**Hearing Report,**

**Comments Received and Responses**

# Hearing Officer's Report

One-Hour Ozone Maintenance Plan  
Updates for the Raleigh/Durham and  
Greensboro/Winston-Salem/High Point  
One-Hour Ozone Maintenance Areas

# Attachment – Davie County Maintenance Area Census Data

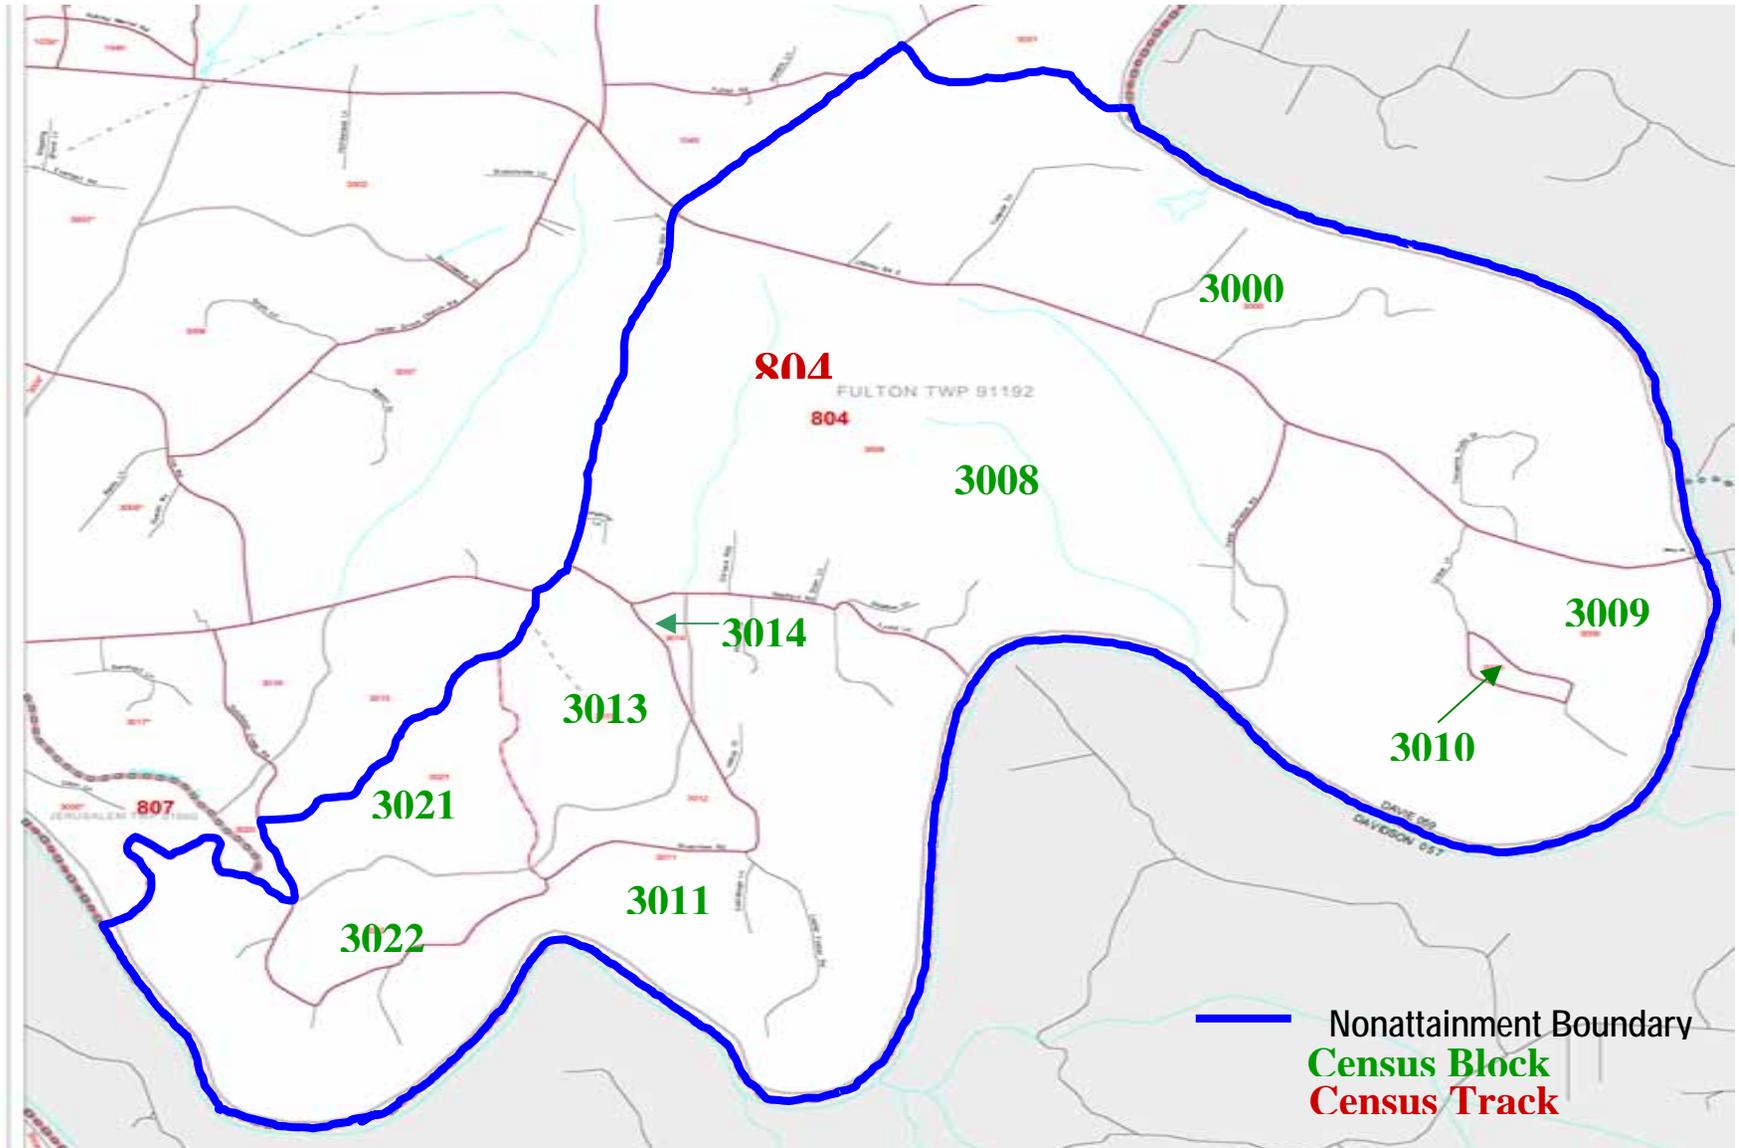
1. Area Source Emissions, Page 3-10. The documentation indicates that the population of the non-attainment portion of Davie County was 248 people according to the 1990 Census and 250 people according to the 2000 Census. Please Confirm.

*This information was confirmed. A map of the non-attainment portion of Davie County with the census block/track numbers labeled is attached. The census population data associated with the tracks within the non-attainment area is also attached.*
